GAS, CONDENSATE AND ROOF DRAINAGE PIPING PLAN AND GAS PIPING RISER DIAGRAM

SUMMERLIN ARBORS PARK
POOL AND POOL BUILDING

NO.	DATE	BY	REVISIONS
1	3/1/00	PLAN CHECK COMMENTS	
2	2/28/02	STORM DRAIN REVISION

Sheet Number: P2.03

GAS AND CONDENSATE DRAIN PIPING PLAN

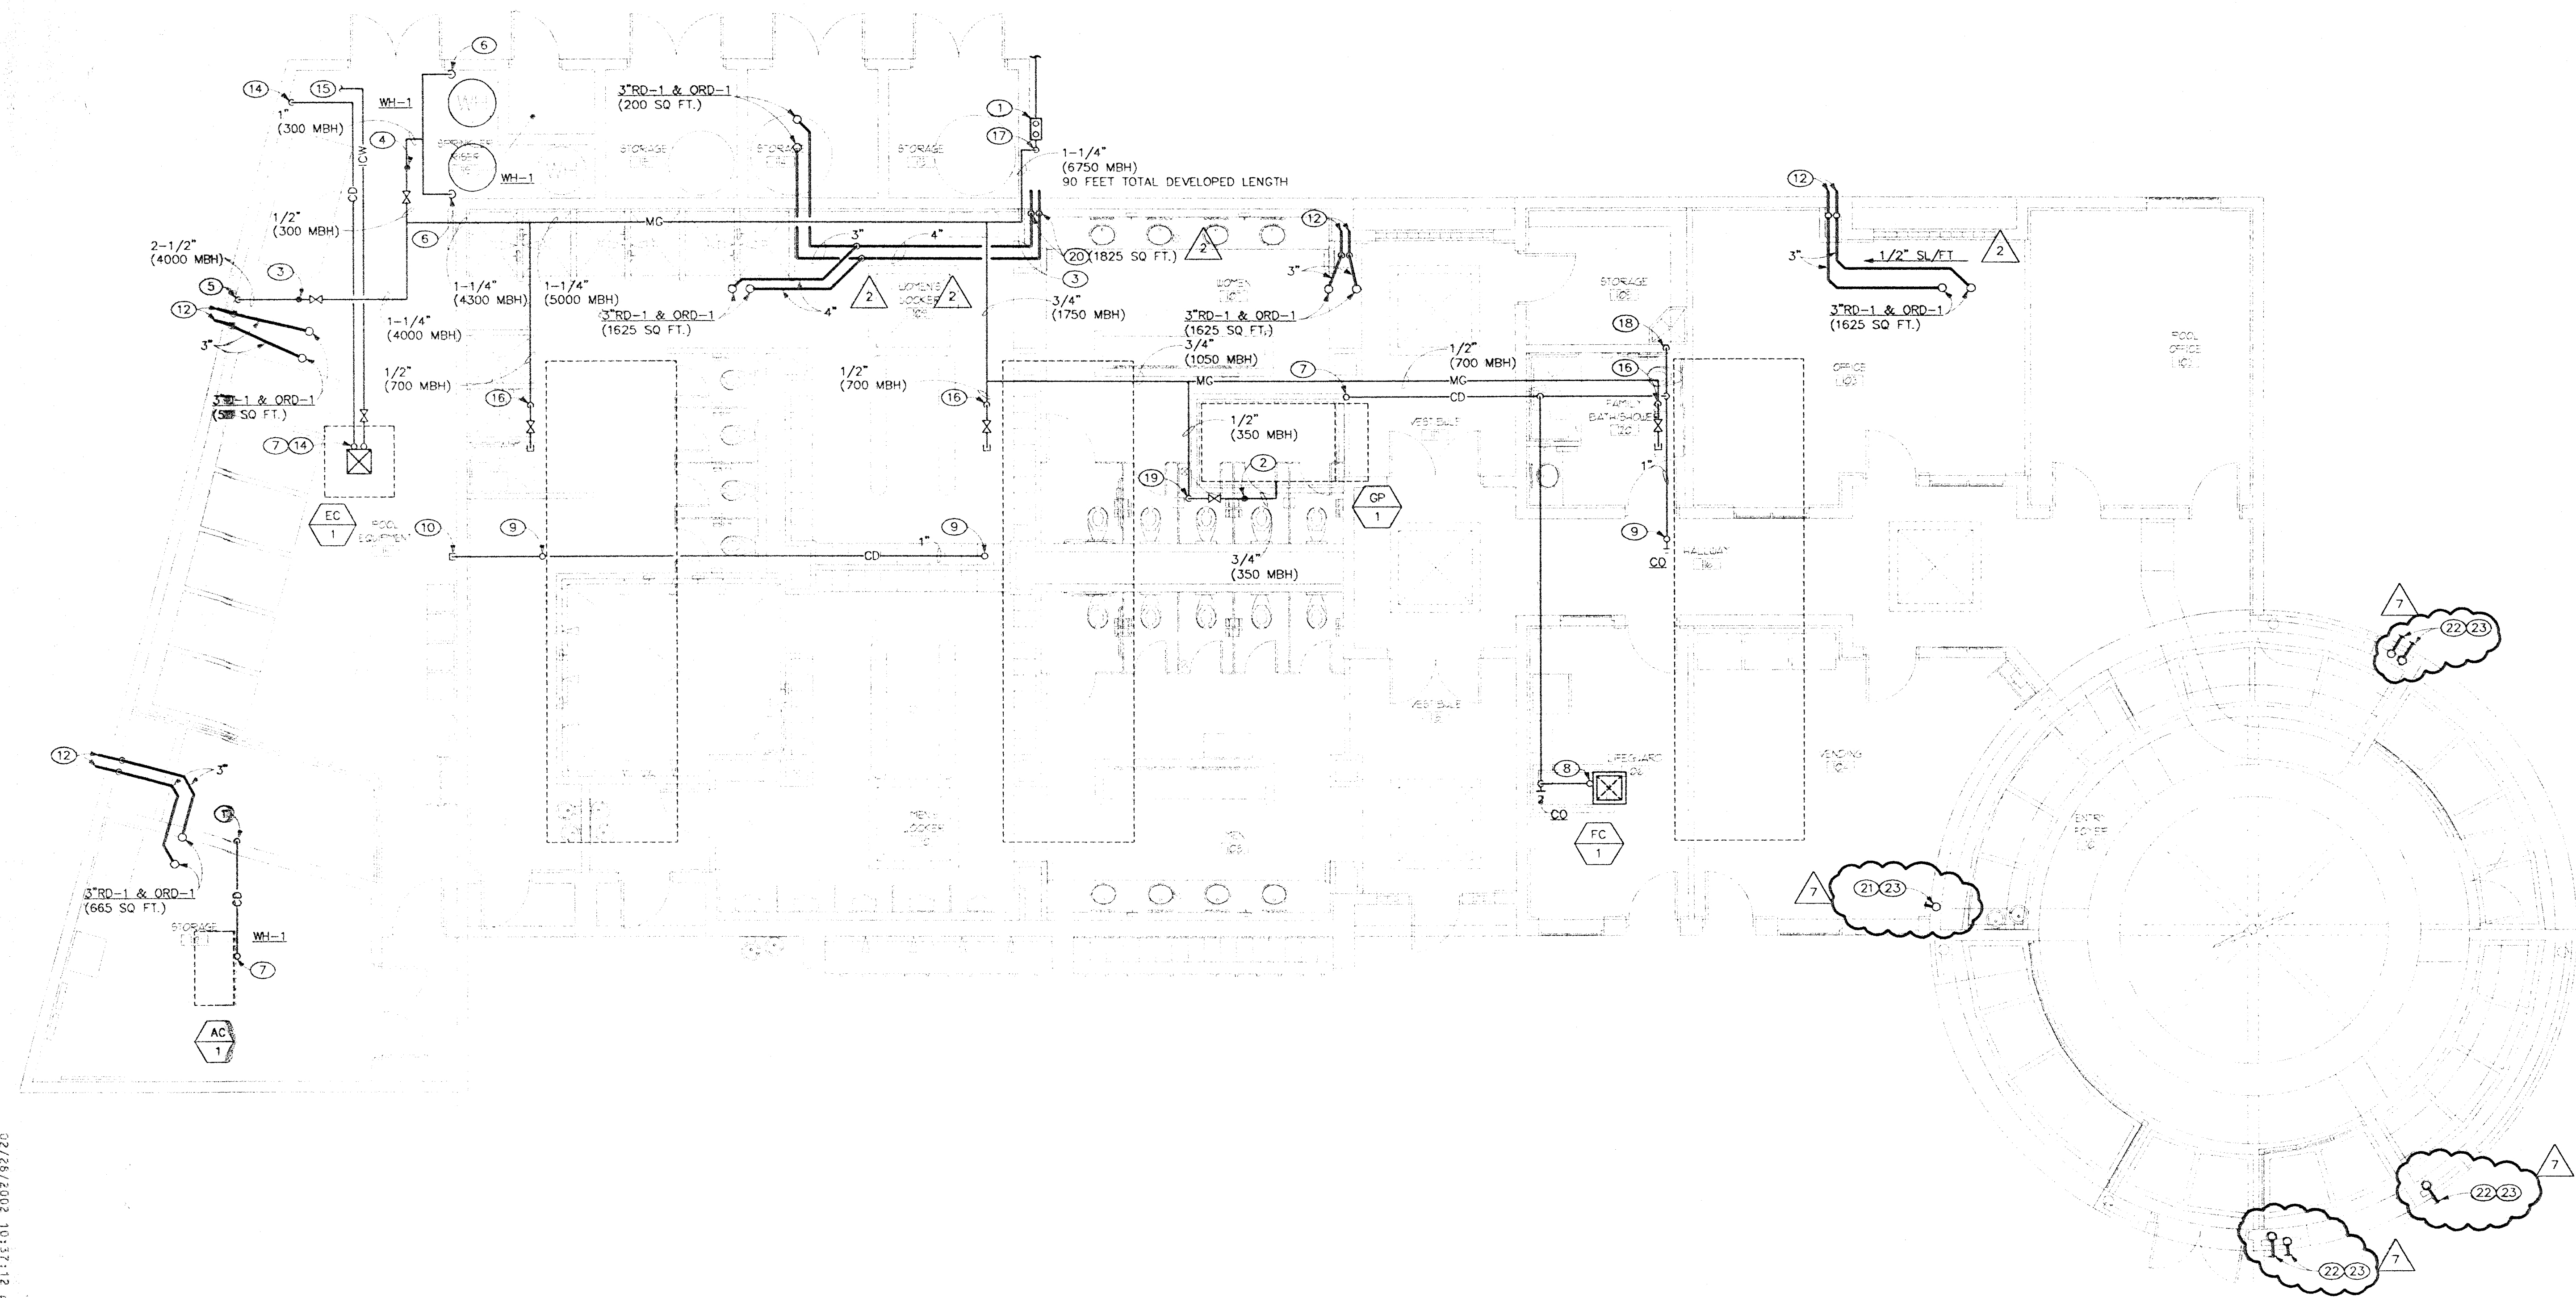
Rainwater piping sized at 2 inch is allowed in vertical installations only per UBC Table 1-1. Horizontal piping shall not be smaller than 3 inch per UPC Table 11-2.
